State of Wisconsin \ Department of Commerce

RULES IN FINAL DRAFT FORM

Rule No.: Chapters Comm 20-25

Relating to: Uniform (1-2 Family) Dwelling Code

APPENDIX section 20.04(6) added:

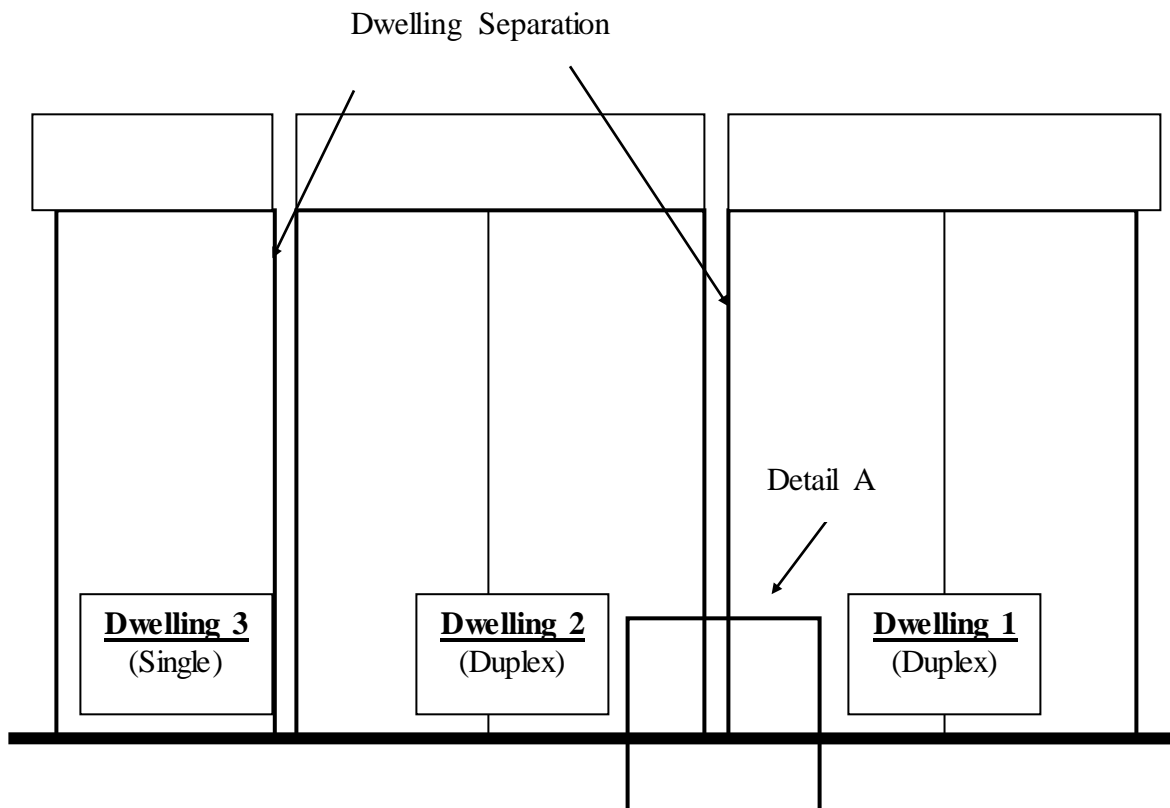
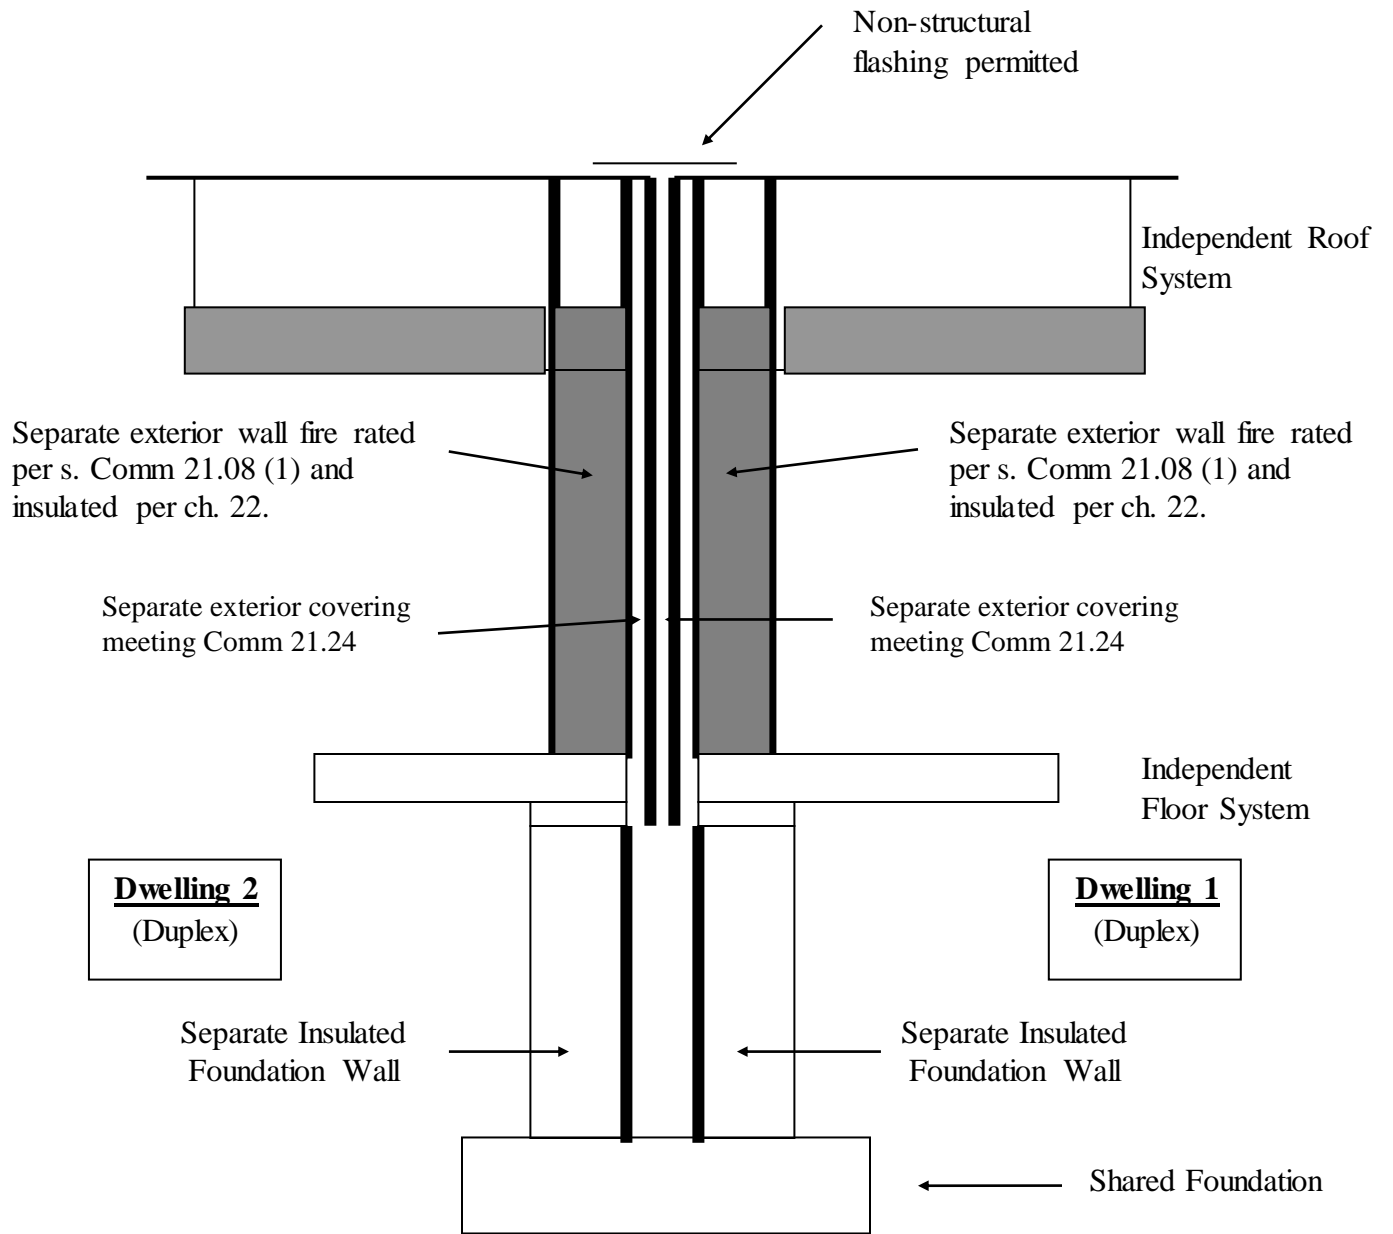
Where 3 or more adjacent but unattached dwelling units are each built with the outside walls that comply with the Uniform Dwelling Code (UDC), the UDC applies throughout and the CBC does *not* apply, even if those outside walls are adjacent to or adjoin each other. If flashing is added over the top of two such adjoining walls, the UDC would still apply.
